The Grandview Estates Rural Water Conservation District

RE: Grandview Estates Rural Water Conservation District 20,
Case Number: SUB16-034
Application Type: SUBDIVISIONREPLAT
Application Name: Compark Village South F2 Final Plat
Due Date: Monday, November 14, 2016

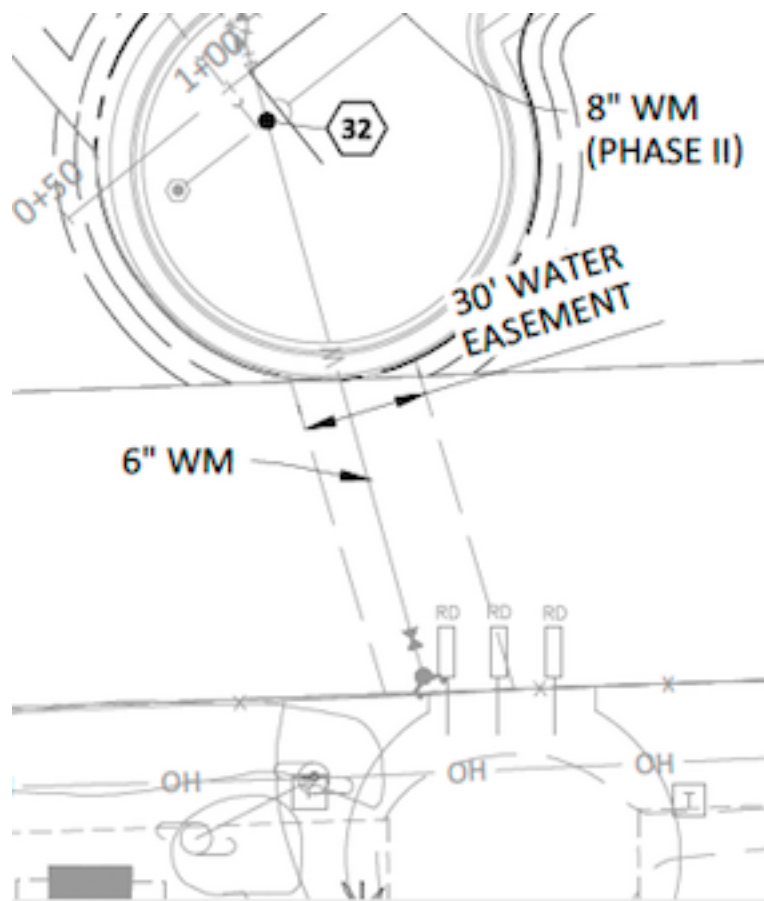
- Signed application is missing the number of single family units (21) and duplex units (72)
- Final Plat 1 of 4 -
 - Dedication commits adjacent land owners to sight easements shown, they have no authority to do that in Grandview Estates.
 - Park land dedication is inadequate at 0.896 acres. Municipal code 13.07.140 (c) (2) provides a formula for park acreage in residential areas as follows:
 -

$$PA = (SFU+DU) \times 0.0239 = 93 \times 0.0239 = 2.22 \text{ acres}$$

- Please increase park acreage.
- Lot numbers are not numbered consecutively as required 13.07.120 (e)
- Final Plat 2 of 4 -
 - Filbert Street should be Filbert Avenue
 - Sewer and water 2 of 14 general notes cover sheet
 - Water Main and services Notes 7, Chlorination and flushing, Chlorine concentration should be 50 mg/L, not 50 mg to 1. How will the spent bleach be disposed?

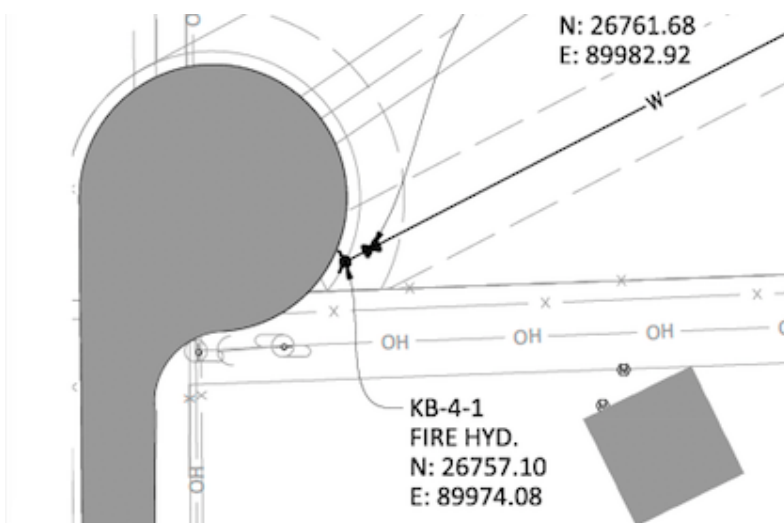
- Water Plan west 4 of 14
 - Six fire hydrants available, one for grandview at First Street, none at Second and third Streets, four in Phase I area and one not accounted for.

- Missing hydrants at Second and Third Streets

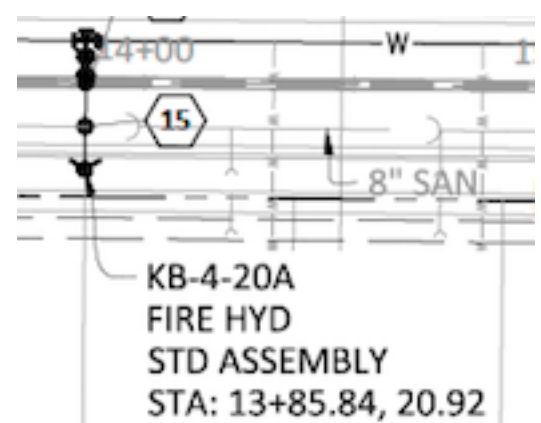
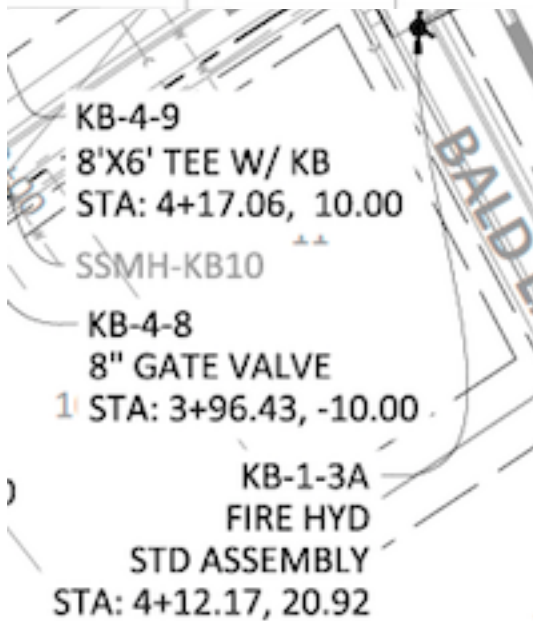
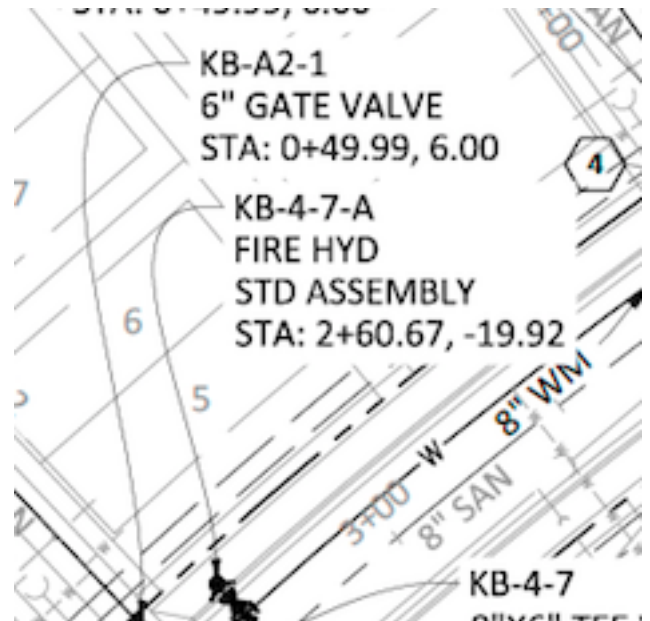
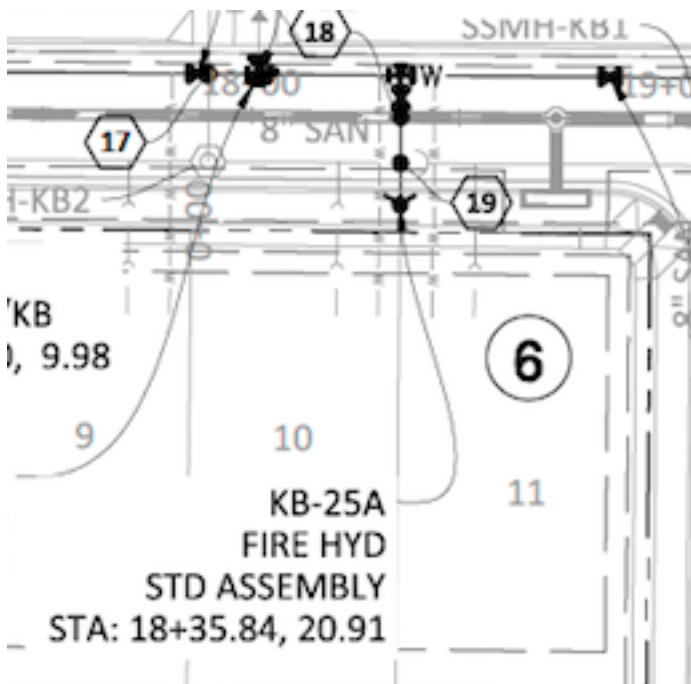
- Fire hydrant at First Street Cul-de-sac
-

- Fire Hydrants in subdivision

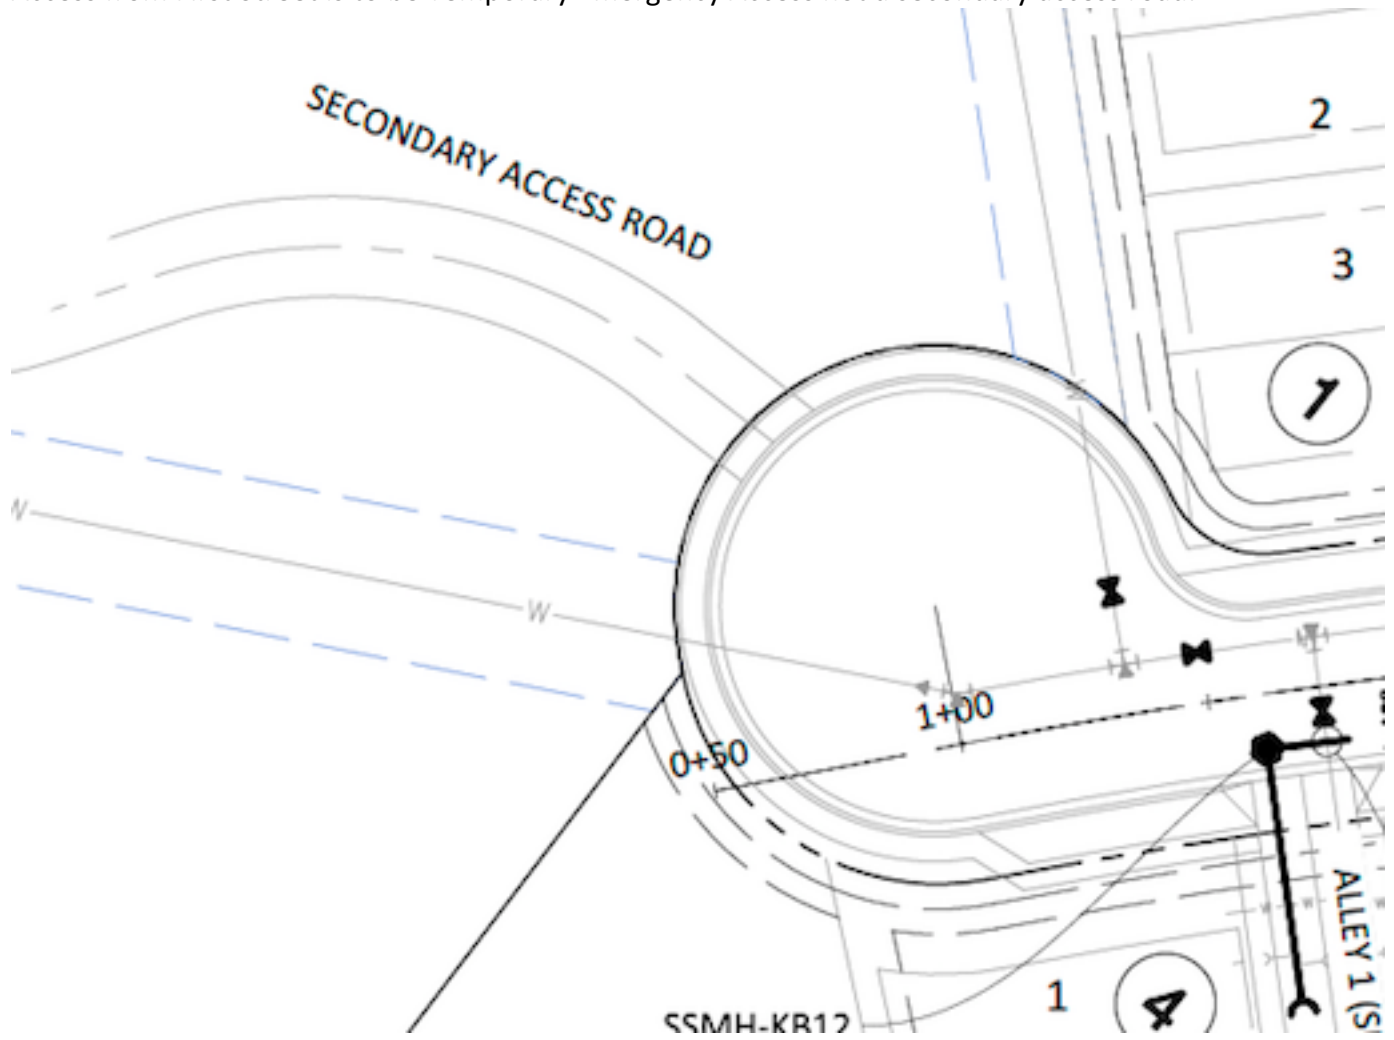
- Access from First Street is to be Temporary Emergency Access not a secondary access road.
